ARCHITECTURAL REVIEW BOARD STAFF REPORT

Project #/Name	ARB-2022-17: Rio Point Initial Site Plan
Review Type	Initial Site Development Plan
Parcel Identification	06100000016700, 061000000167C0
Location	878 E. Rio Road (See Figures 1 and 2.)
Zoned	Planned Residential Development (PRD) / Entrance Corridor (EC)
Owner/Applicant	Rio Pt. LLC/Timmons (Craig Kotarski)
Magisterial District	Rio
Proposal	To construct 327 multi-family and single-family dwelling units in apartment buildings and attached townhouses with associated site improvements.
Context	The property is occupied by a house, sheds, agricultural structures, and open fields and is elevated above the John Warner Parkway and above Rio Road at the Parkway intersection. The Parkway borders the property on the northwest and west. The Rivanna Trail runs through a park easement adjacent to the Parkway. CATEC is located across the Parkway to the north. To the northeast, east, and southeast are residential developments including Belvedere, Reserve at Belvedere, Dunlora, Dunlora Forest, Shepherd's Ridge, River Run, Treesdale, Stonehenge, and Stonewater.

Visibility	The proposed development will be readily visible from the Entrance Corridor

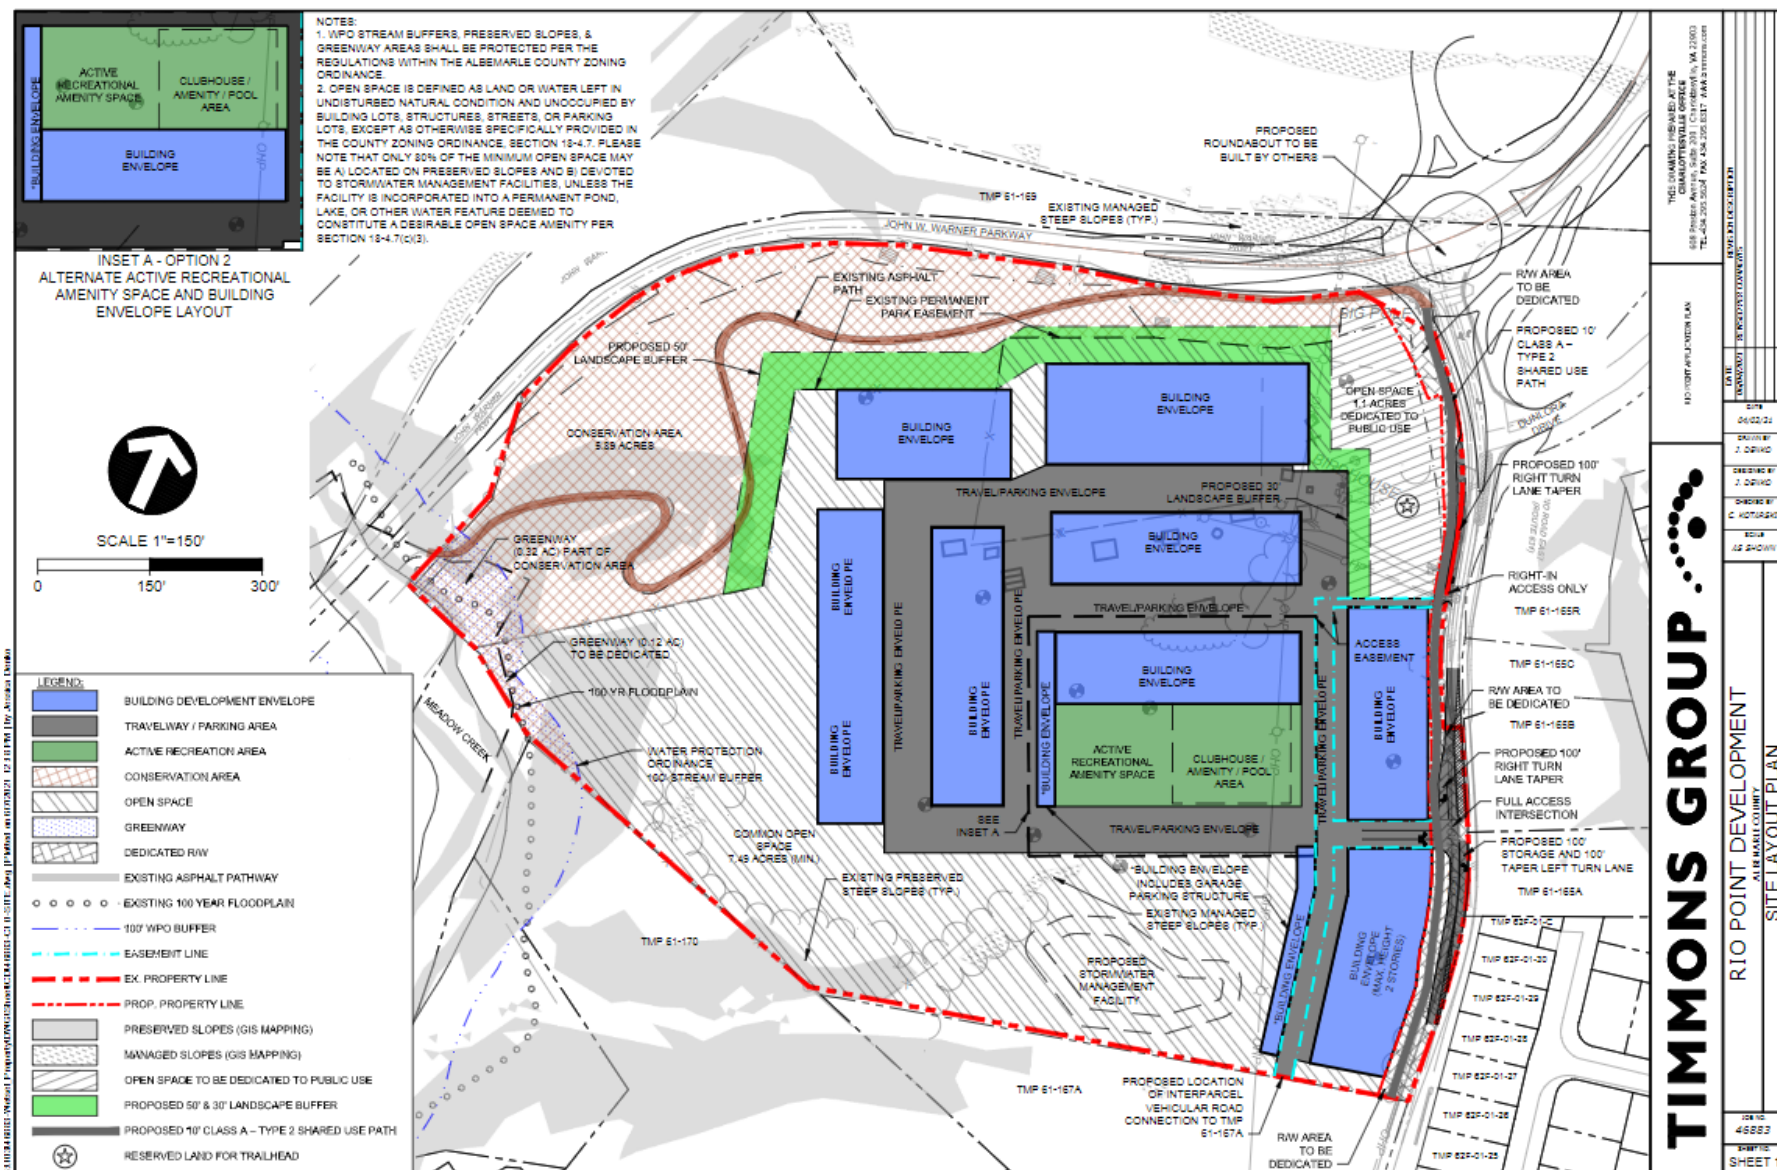
Changes from the approved Application Plan (See Figures 3 and 4):

1. In the rezoning application plan, a building occupies the northwest corner of the development. The Initial Site Plan shows an amenity area in that location and the building immediately to the east is identified as “potential future”.
2. The Initial Site Plan shows multiple building footprints within what were previously shown as single building envelopes on the rezoning application plan.
3. The footprints of buildings closest to Rio Rd. have shifted westward away from Rio and towards an interior street.

Figure 4: Current site layout plan (SDP2022-09 2/7/2022).

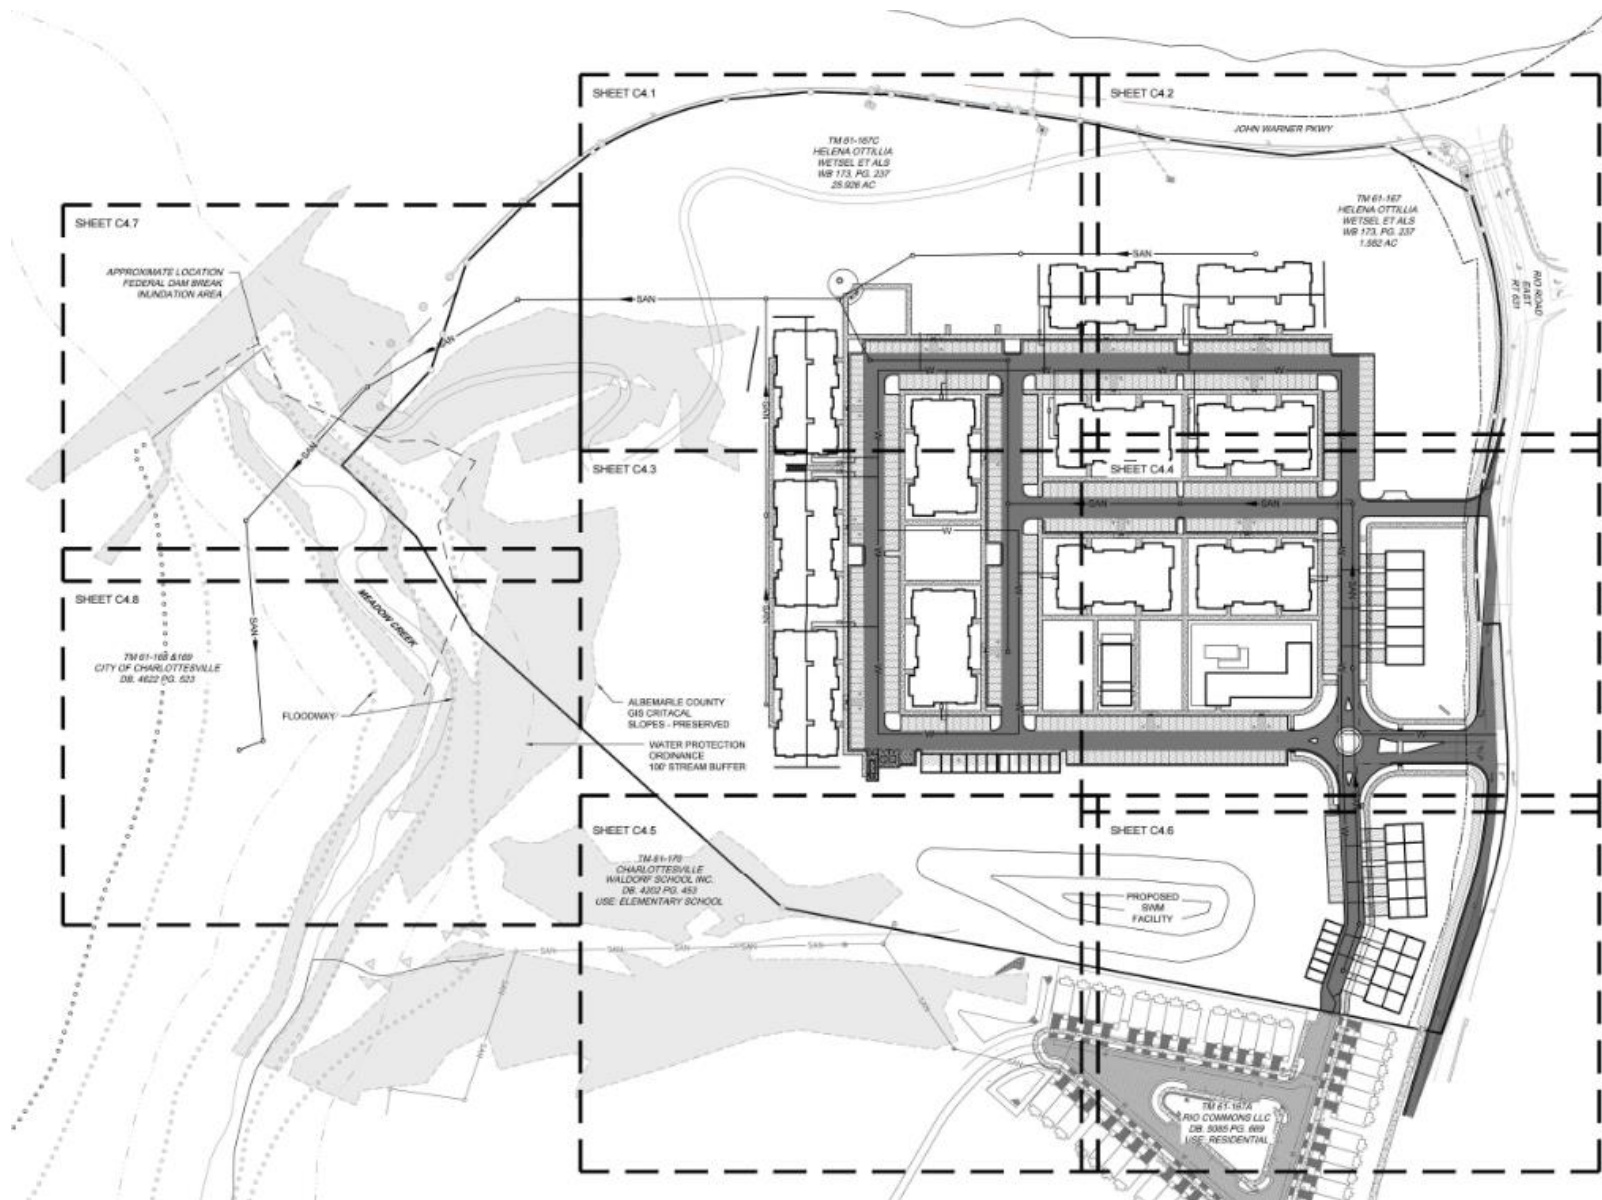
1. Site layout, building footprints, “potential future building”
2. The stormwater facility located north of Buildings 8 and 9
3. The appearance of the retaining wall east of Building 8

- Regarding requirements to satisfy the design guidelines as per § 18-30.6.4c(2), (3) and (5) and recommended conditions of initial plan approval:
 - The ARB recommends approval of the Initial Plan with the following condition:
 1. Move the stormwater facility located north of Buildings 8 and 9 out of the landscape buffer and to a location that will not have a negative visual impact on the EC.
- Regarding recommendations on the plan as it relates to the guidelines: None.
- Regarding conditions to be satisfied prior to issuance of a grading permit:
 1. Maintain grading outside the driplines of trees to remain. Show tree protection fencing on, and coordinated throughout, the grading, landscaping, and erosion and sediment control plans.
